**ANGEL PLACE
LEVEL 8, 123 PITT STREET
SYDNEY NSW 2000**

2 September 2021

SUBMISSION | STATE SIGNIFICANT DEVELOPMENT APPLICATION | SSD-10412

Figure 12 – Approved Boat Harbour Drive access

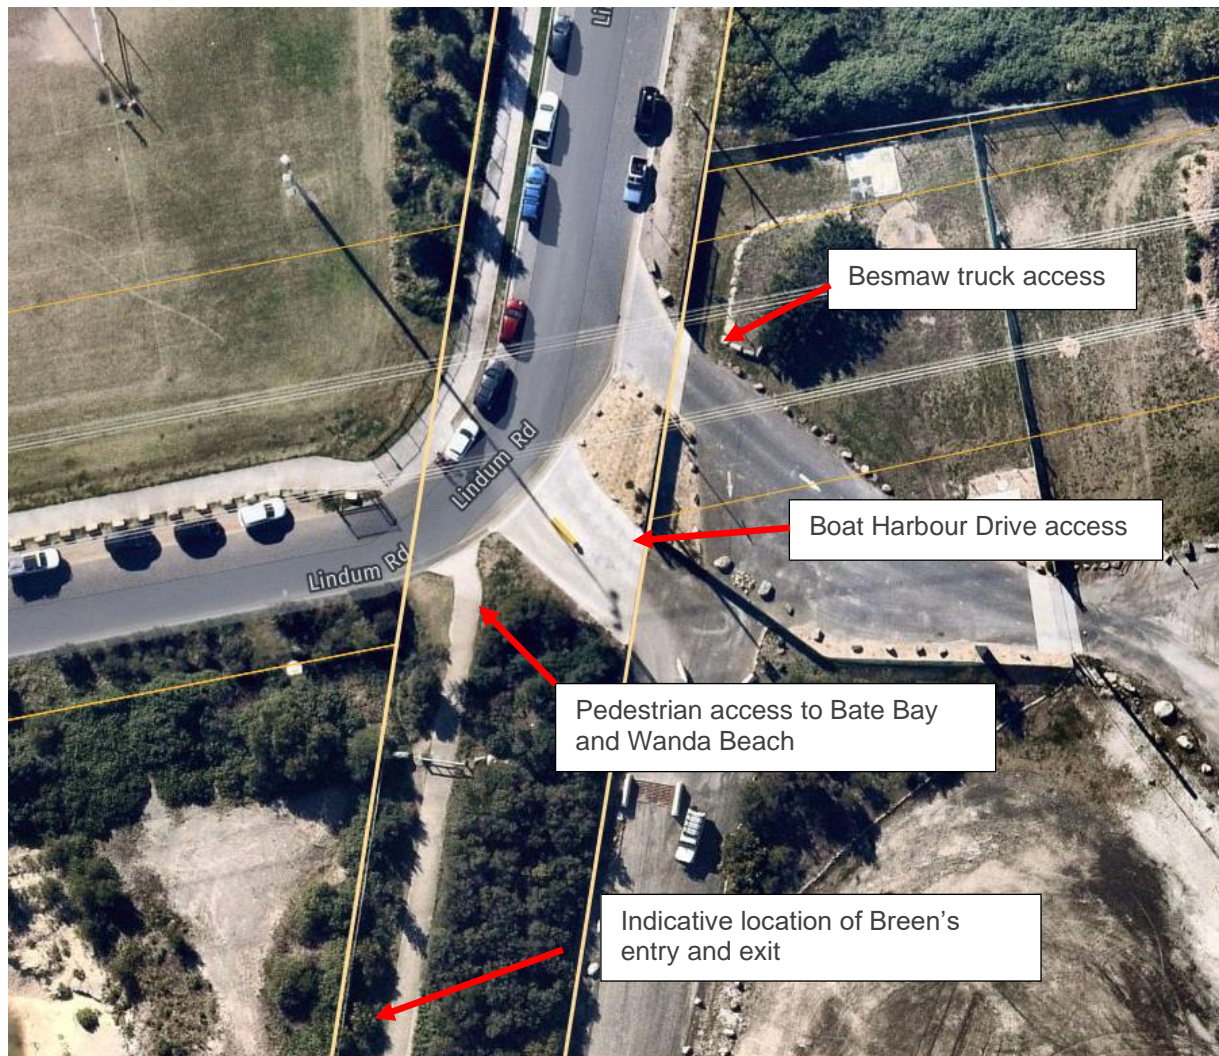
and separate access to Boat Harbour. Private vehicles using the approved vehicle access off Lindum Road will be in direct conflict with commercial trucks entering the proposed Breen waste management facility at this junction (**Figure 12 and 13**).

Figure 13 – Proposed Lindum Road extension which traverses the existing pedestrian pathway and fails to consider the Boat Harbour Drive access resulting in a conflicting access points

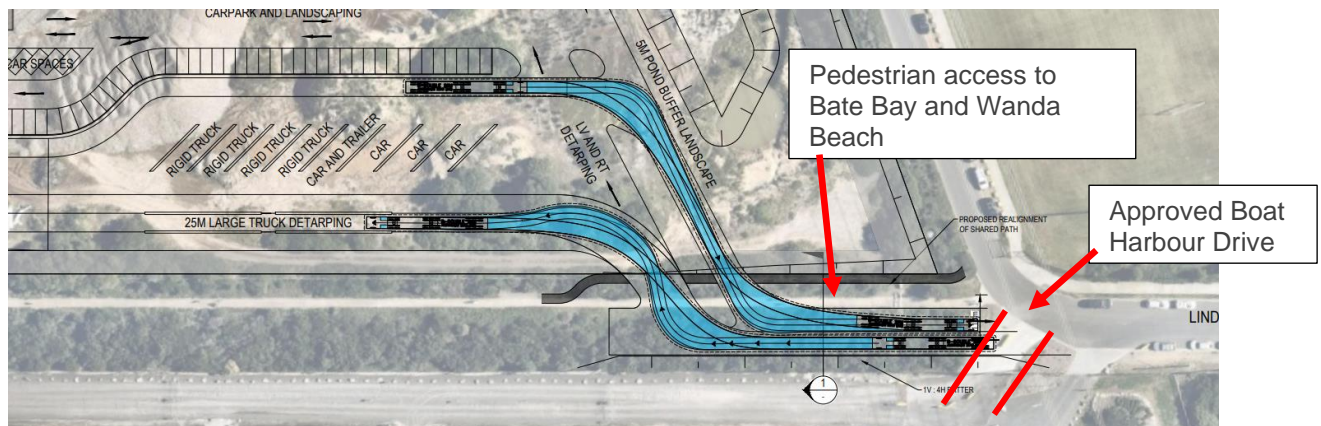
- Alternate locations must be explored o remove the significant conflict at this pinch point. The proposal includes a high volume of truck movements which need to cross a regularly trafficked pedestrian pathway (including young children) accessing Bate Bay. There is also a conflict with the existing Boat Harbour Drive access as well as it being entry point for trucks entering Besmaw’s site. The proposed location of the truck access (two way traffic) combined with the projected volumes, will create a choke point, presenting a pedestrian and traffic hazard that is not appropriate.

- A swept path analysis has not been provided to determine if in-going and outgoing trucks can bypass one another without resulting in a loss of on street carparking.
